FORD E4OD NEW DESIGN CENTER SUPPORT SERVIVE KIT WITH BALL BEARING

CHANGE:

DIMENSION "A" SERVICE KIT = 1.938" 1995 PRODUCTION = 1.710"

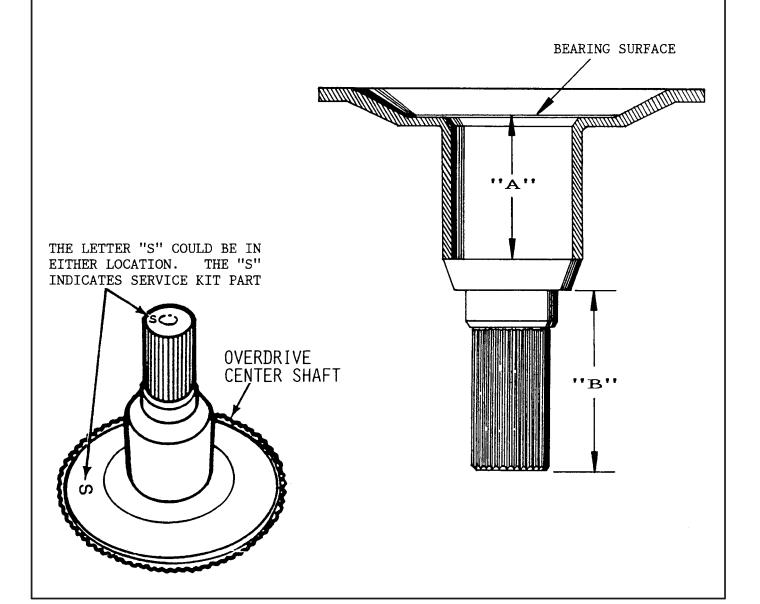
(1) CENTER SUPPORT - Different machining dimensions on the inside bore, to accommodate an added ball bearing that will now support the overdrive center shaft. The new design ball bearing center support assembly can be identified as a "Service Part", by the letter "S" stamped on the hub, in the location shown in Figure 2. The Service Kit Ball Bearing Center Support has different dimensions than 1995 production ball bearing center support. Refer to Dimension "A" on the cutaway drawing in Figure 2.

OUTPUT SHAFT

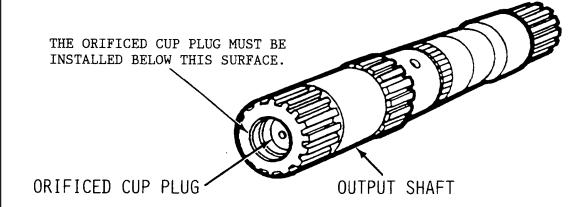
OUTPUT SHAFT - Small bushing MUST be removed and the orifice cup plug included in the service kit MUST be installed, to accommodate the removal of the pilot from the overdrive center shaft. This will now ensure that lube oil will be directed to the proper areas. Refer to Figure 4 for the bushing removal and orifice cup plug installation. The orifice cup plug in this service kit is different dimensions than the 1995 production models, and will fit ONLY an output shaft that had the bushing.

THE ORIFICED CUP PLUG IN THIS SERVICE KIT IS DIFFERENT DIMENSIONS THAN 1995 PRODUCTION MODELS, AND WILL FIT NOTE:

ONLY AN OUTPUT SHAFT WITH A BUSHING.

OVERDRIVE CARRIER AND INPUT SHAFT USAGE

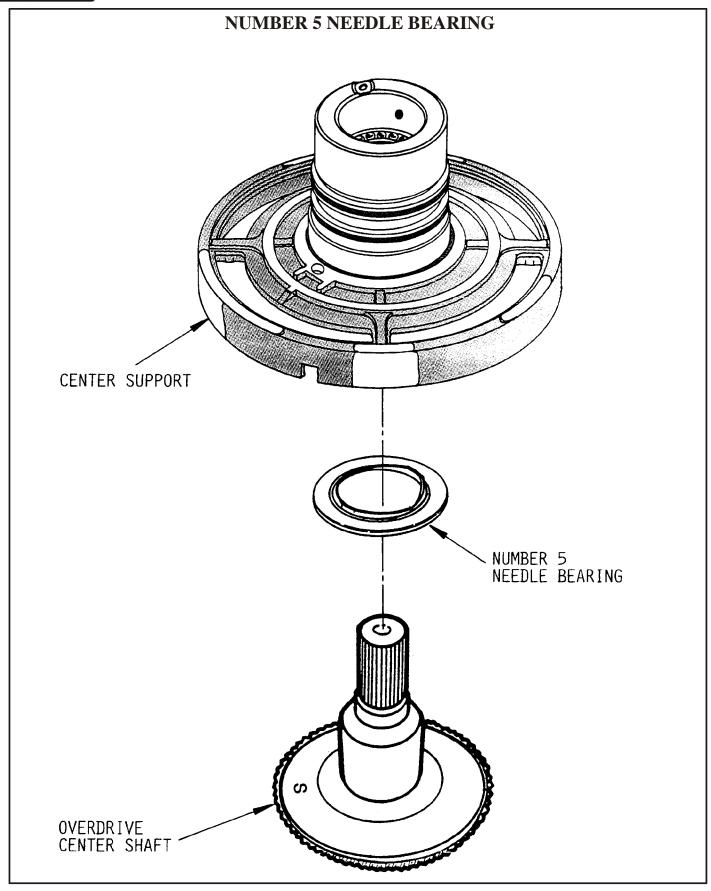
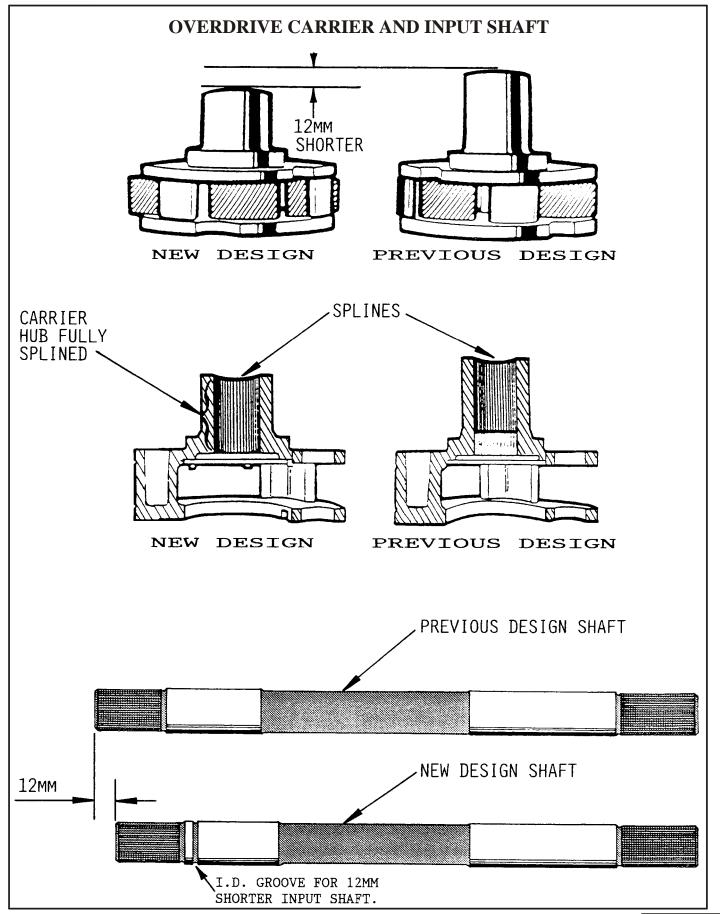
SPECIAL NOTE: There is also an updated Overdrive Carrier and Input Shaft, available under OEM part number F4TZ-7B446-B, to help improve durability. Both pieces have different dimensions than the previous parts, as shown in Figure 6. The new overdrive carrier hub is 12mm (-472") shorter than the previous model, and the internal splines now run the full length of the hub. The Input Shaft is also 12mm (.472") shorter than the previous models, to accommodate the new overdrive carrier, and has I.D. groove cut in shaft for identification (See Figure 6).

DO NOT MIX LONG AND SHORT COMPONENTS.

Refer to Figure 7 to ensure that you have built the unit with the matching components. The Input Shaft must extend 1.5" past the end of the oil pump stator, if the correct input shaft and overdrive carrier were used. Refer to Figure 7 for proper assembly dimensions.

THE INPUT SHAFT MUST EXTEND 1.5" PAST THE END OF THE PUMP STATOR IF THE CORRECT INPUT SHAFT AND OVERDRIVE CARRIER WERE USED.
